# PARTS & SERVICE NEWS

REF NO.	AT00017
DATE	Mar. 6, 2000
(C)	Page 1 of 4

**SUBJECT:** INTRODUCTION OF IMPROVED, WEAR-RESISTANT 2ND, 3RD CLUTCH FOR TRANSMISSION

**APPLICATION:** WA500-3/3LC Wheel Loaders, S/N 50001 thru 50751 & A70001 thru A70642

#### 2-3. The lubrication means for the 2nd clutch has been improved (since the number of the clutch discs and plates has been increased)

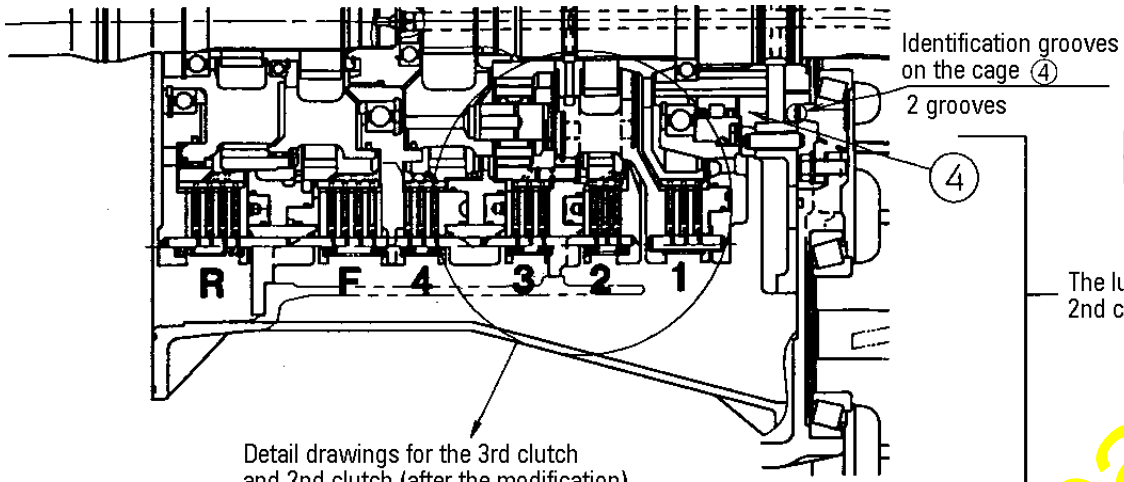
- (1) The hole position in the front section of the hub ⑥ has been changed.  
 Provided with the identification grooving.  
 (Refer to the drawing indicated on page 4.)
- (2) The position of the drilled hole for lubrication in the cage ④ has been changed.  
 Provided with the identification grooving.  
 (Refer to the drawing indicated on page 4.)

Detail drawings for the 3rd clutch and 2nd clutch (after the modification)

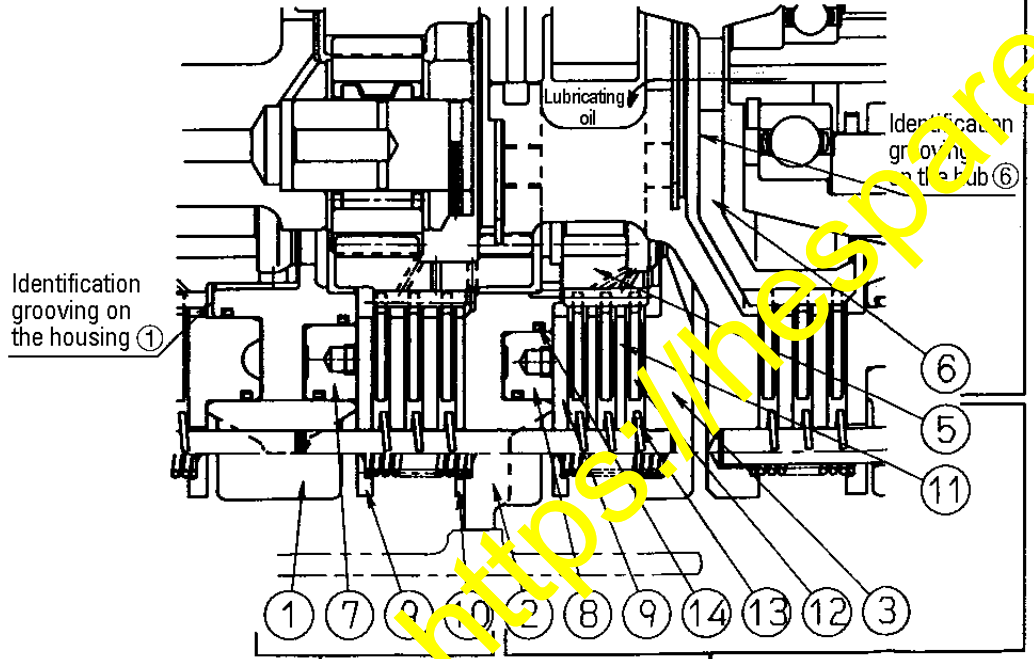
- (1) Be sure to insert the plate ⑩ for the 3rd clutch section.
- (2) The piston for the 3rd clutch section has been separated into the piston part ⑦ and the plate part ⑨.  
 Assemble them to the same shape of the piston for the 2nd clutch section.

The lubrication means for the 2nd clutch has been improved.

Modification with the 2nd clutch

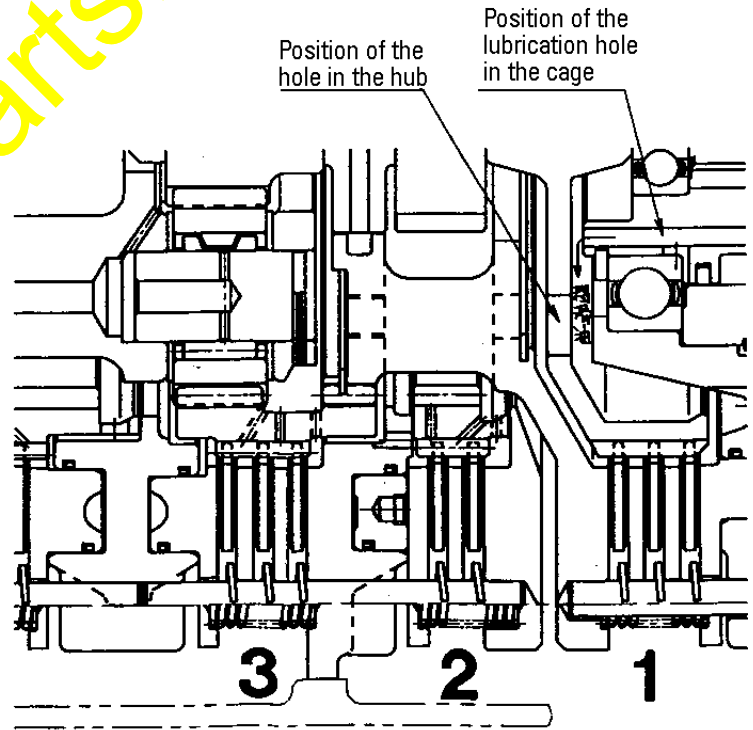
- (1) The material and quantity of the disc ⑫ have been changed.  
 Material : Molded resin friction material → Sintered alloy  
 Disc color : Black → Brass color  
 Quantity : 2 sheets → 3 sheets

- (2) The thickness and quantity of the plate ⑪ have been changed.  
 Thickness : 5 mm → 3.2 mm  
 Quantity : 1 sheet → 2 sheets
- (3) The width of the external gear of the ring gear ⑤ has been widened.  
 Gear width : 23.5 mm → 28.5 mm

- (4) The thickness of the piston plate ⑨ has been changed.  
 Thickness : 7 mm → 5 mm
- (5) The thickness of the contact section to the disc of the housing ③ has been changed.  
 Thickness of the contact section to the disc : 19 mm → 16.2 mm

- (6) The bore diameter and wall thickness of the piston ⑧ have been changed.  
 Bore diameter :  $\phi$  285 mm →  $\phi$  290 mm  
 Wall thickness : 17.5 mm → 16.5 mm  
 (The 2nd clutch piston before this modification is the same part as the 3rd clutch piston after this modification. Therefore, if the piston is not damaged, it can be reused for this modification.)

- (7) The small diameter of the piston chamber in the housing ② has been changed.  
 Small diameter :  $\phi$  285 mm →  $\phi$  290 mm
- (8) The quantity of the equal separation spring ⑬ being used for the 2nd clutch section has been changed.  
 Quantity being used for the 2nd clutch section: 10 units → 15 units

- (9) The piston seal ⑭ has been changed along with the change of the bore diameter of the piston.
